Access Compliance Report

Public Rights-of-Way

Intersection ID: 16769	Main Street: KELLY_ST	Cross Street: SUMMEY_AV	Location: NE
ADA ID: E0CC823A02B3	Ramp Type: BlendTrans1	Initial Pass/Fail: Fail	Overall Compliance: No
			Severity Score: 36.25

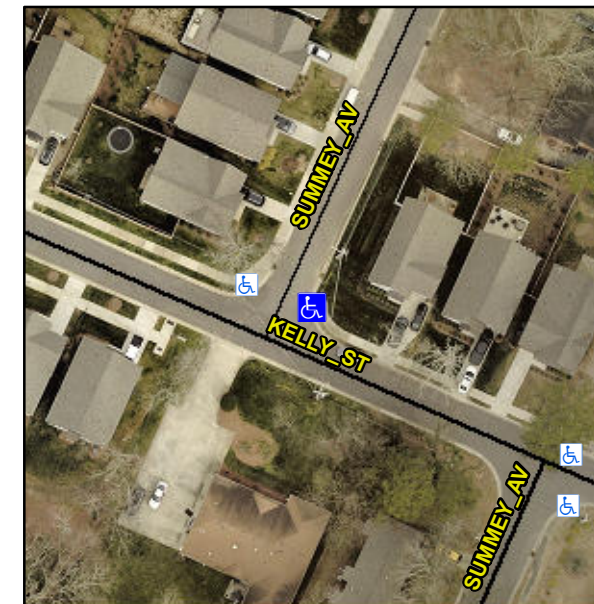
Not Found, R304.5.1, R304.5.3

Compliance	Description	Data	Compliance	Description	Data
N/A	Ramp Length (in)	85.0	Yes	BlendTrans Slope (%)	4.3
No	Ramp Width (in)	28.0	No	BlendTrans XSlope (%)	2.8
N/A	Flare Type LT	N/A	N/A	Flare Type RT	N/A
N/A	Flare Slope LT (%)	N/A	N/A	Flare Slope RT (%)	N/A
N/A	Flare Traversable LT?	N/A	N/A	Flare Traversable RT?	N/A
N/A	Landing Length (in)	N/A	N/A	DWS Provided?	N/A
N/A	Landing Width (in)	N/A	N/A	DWS Contrast?	N/A
N/A	Landing Slope (%)	N/A	N/A	DWS Length (in)	N/A
N/A	Landing X Slope (%)	N/A	N/A	DWS Full Width?	N/A
N/A	Landing Curb? (Y/N)	N/A	N/A	DWS Offset (in)	N/A
N/A	Shared Landing?	N/A			
N/A	Gutter Ponding?	N/A	N/A	Gutter Slope (%)	N/A
N/A	Gutter Lip Ht (in)	N/A	N/A	Gutter X Slope (%)	N/A
N/A	Painted X Walk1?	No	N/A	Painted X Walk2?	N/A
	X Walk 1 Direction	To NW		X Walk 2 Direction	N/A
	X Walk 1 Width (in)	N/A		X Walk 2 Width (in)	N/A
	X Walk 1 Slope (%)	1.5		X Walk 2 Slope (%)	N/A
	X Walk 1 X Slope (%)	0.6		X Walk 2 X Slope (%)	N/A

N/A	Ramp inside XWalk1?	N/A	N/A	Ramp inside XWalk2?	N/A
	Road Slope (%)	0.6		Clear Space?	N/A
	Road X Slope (%)	1.5	N/A	Clear Space to XWalk (in)	N/A
N/A	Any Obstructions?	N/A	N/A	Storm Grate/Utility Hazard?	N/A
	Obstruction Type			Storm Grate/Utility Type	
		N/A			N/A
			Yes	Surface Condition? (G/P)	Good
			No	Curb Slope (%)	8.5

Remove & Replace Curb Ramp With Two New Directional Ramps or Equivalent.
